30/13-00B 4710 Waverly Avenue  
(Garrett Park Historic)

## Changes to Plans for

4710 Waverly Avenue, Garrett Park, MD, 20896-0424

Permit Number: 232765

**FIRST FLOOR PLAN**

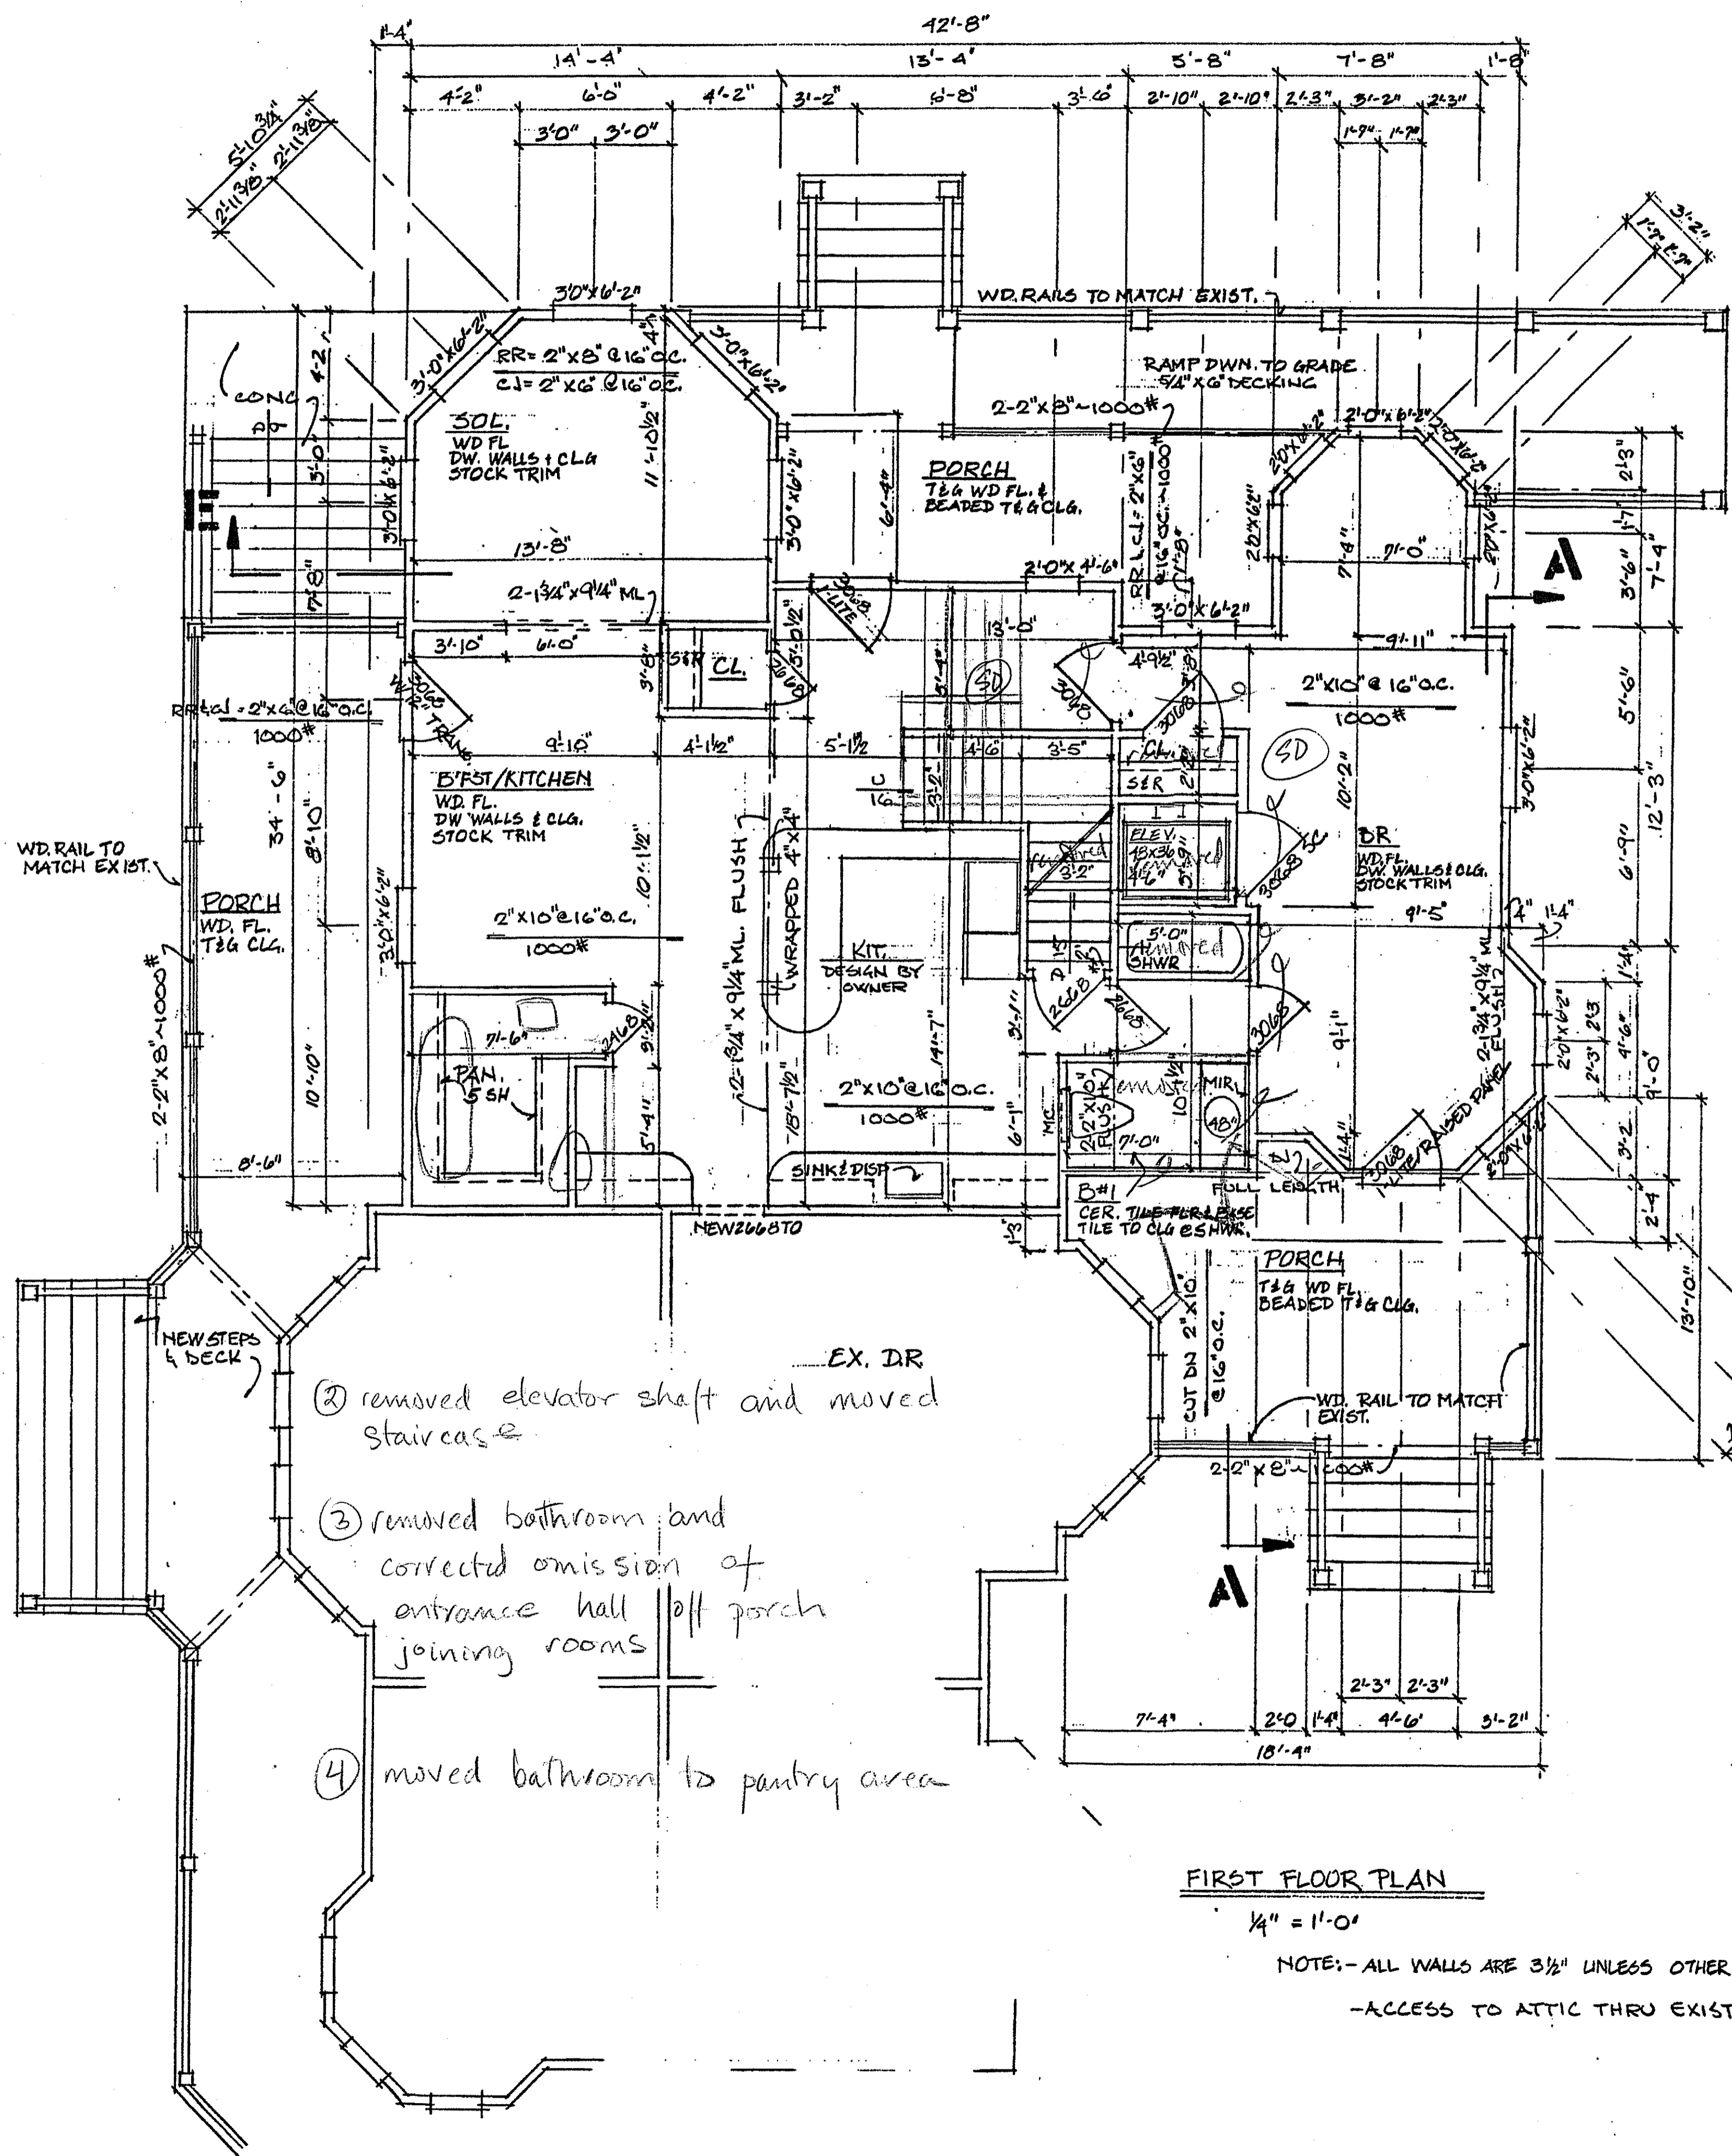
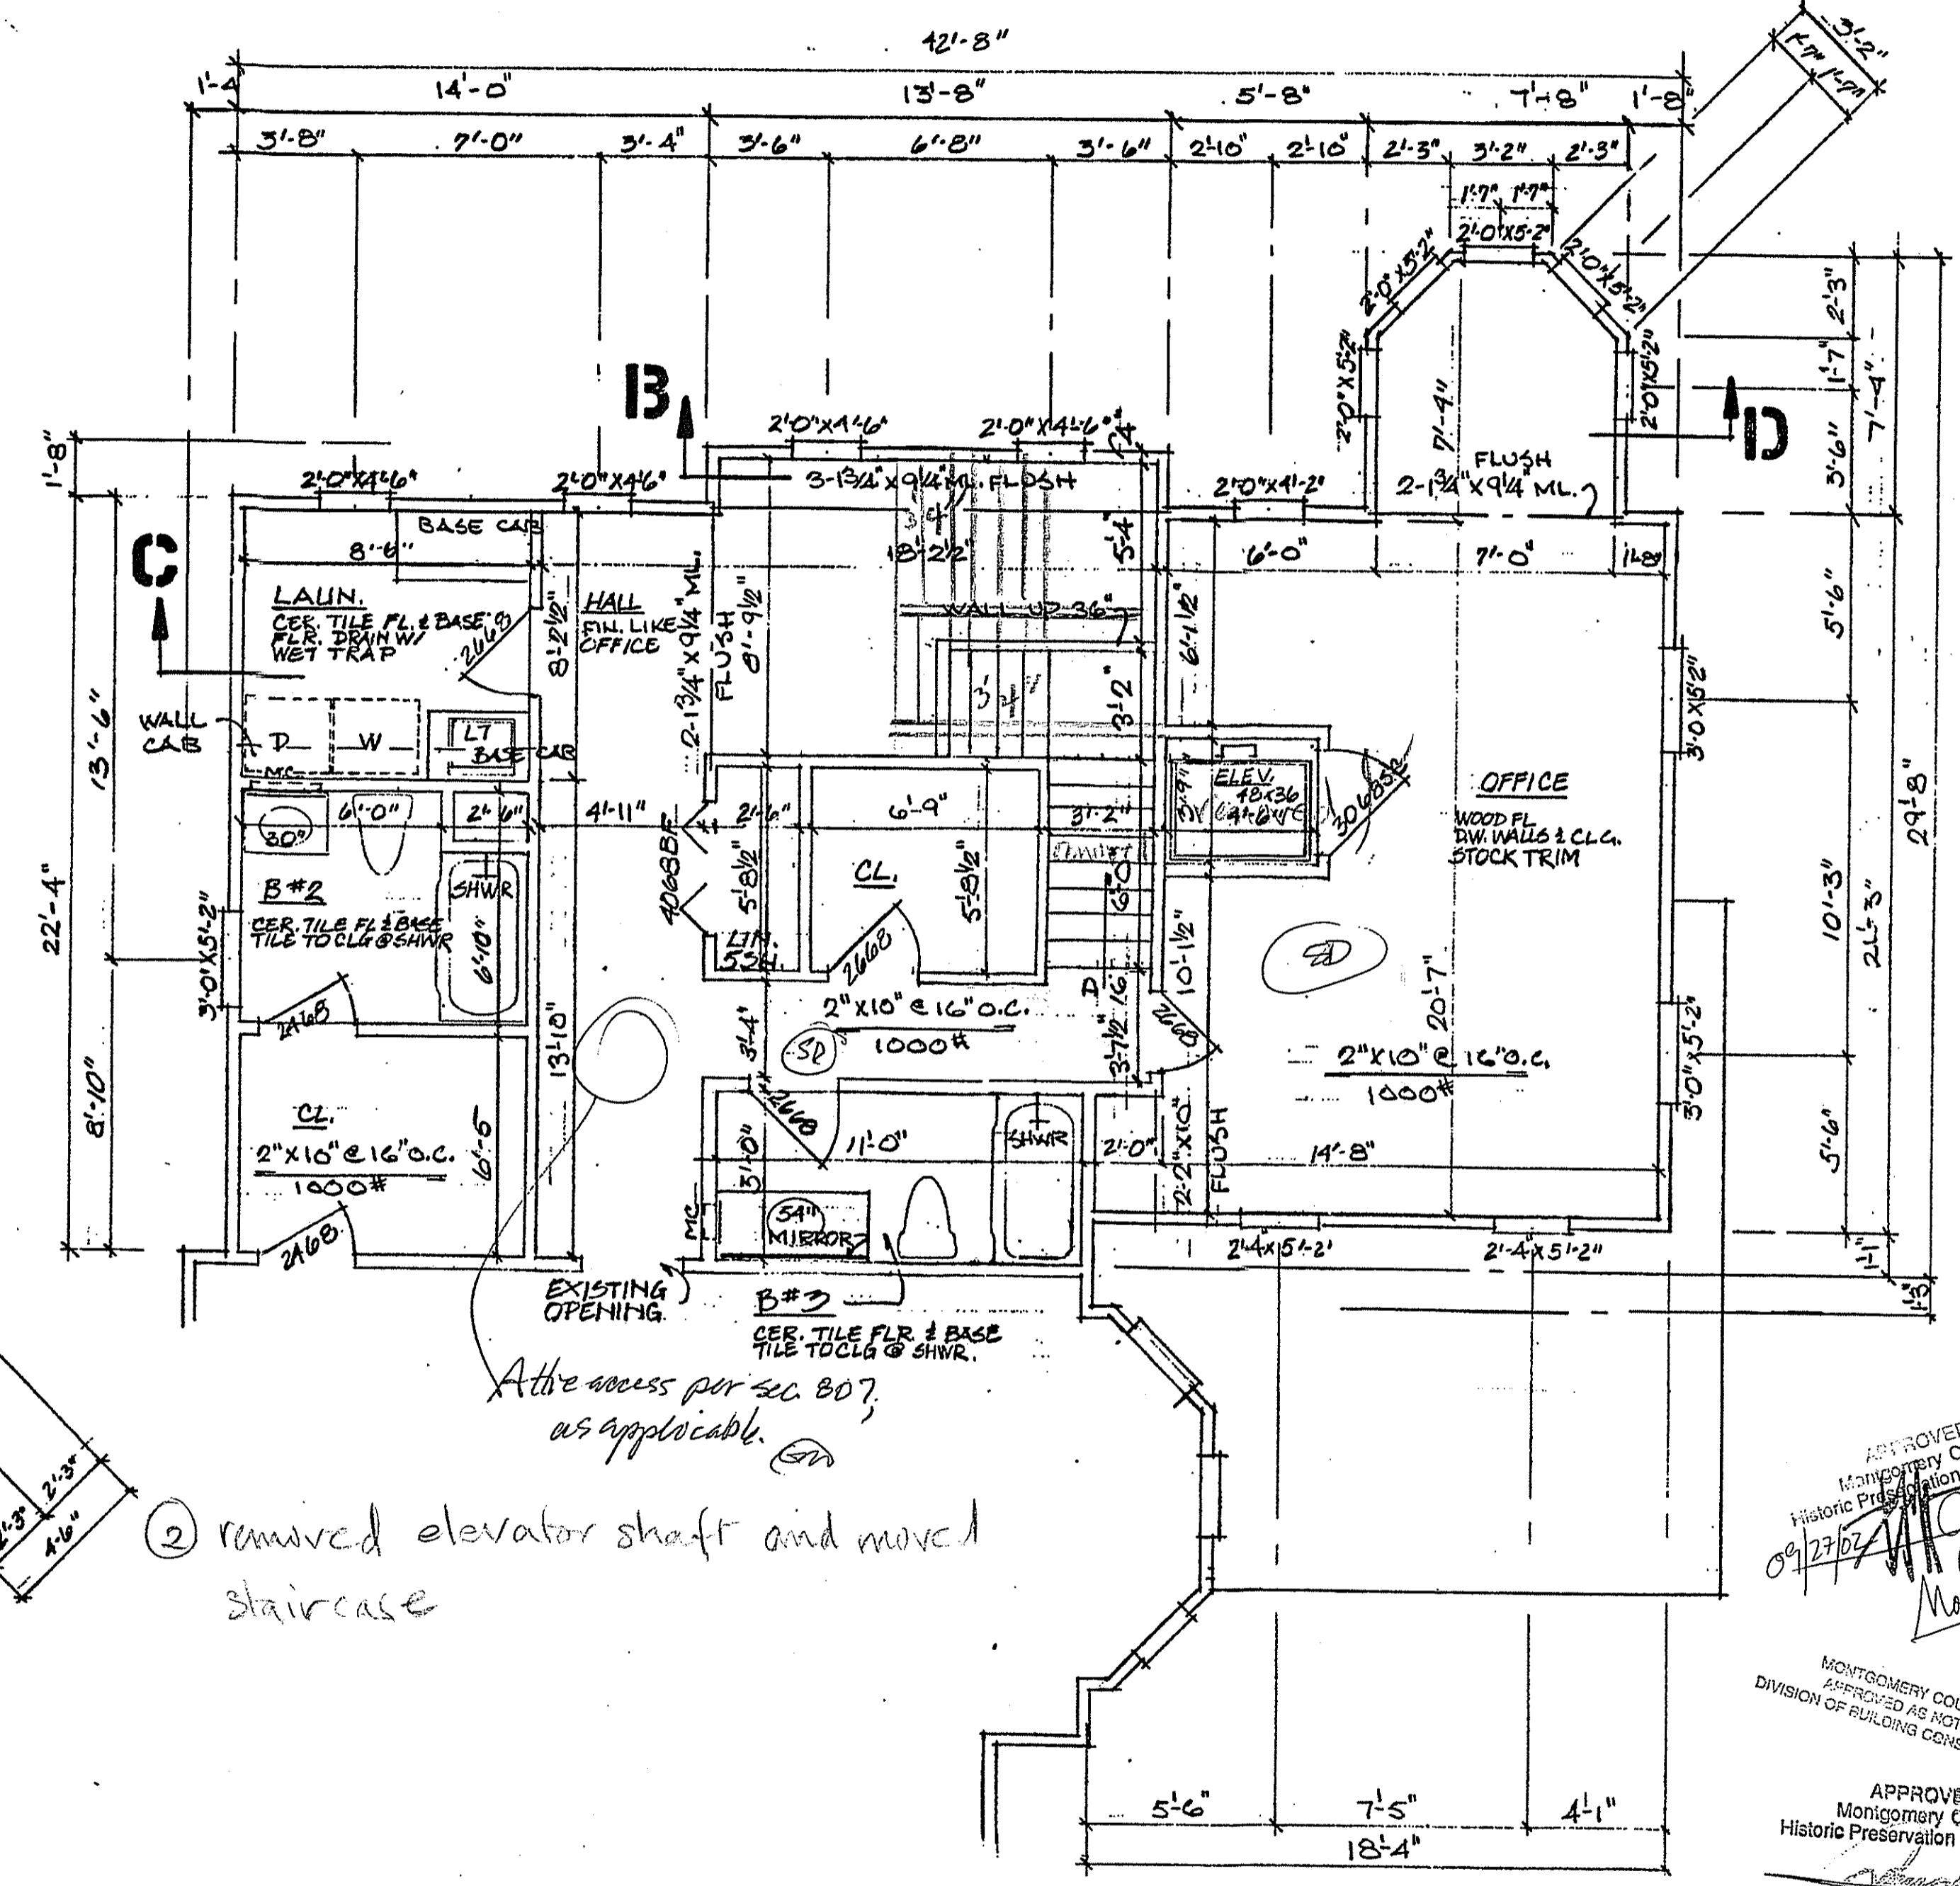
2. **Drawings 1 and 2. Basement, First and Second Floor Plans:** Removed elevator shaft. Moved staircase to rear of house.
3. **Drawings 2, 3 and 4. First Floor Plan and Front and Right Elevations:** Removed bathroom and corrected omission by architect of entrance hall off porch joining old house to new house.

4. **Drawing 2. First Floor Plan:** Moved bathroom to pantry area (left side of first floor plan).
5. **Drawings 6, 7 and 7a. Structure, Third Floor and Roofing Plans:** The architect's roof plan was incorrect. The ridge plate should not have been used with the knee wall, which began to move. The structural engineer from Jolles and McKenzie visited the site and established revised structural plan for a supported roof beam with supports down to the footings in the basement floor (drawing dated January 4, 2002).

- ① removed elevator shaft and moved staircase
- ② removed bathroom and corrected omission of entrance hall off porch joining rooms
- ④ moved bathroom to pantry area
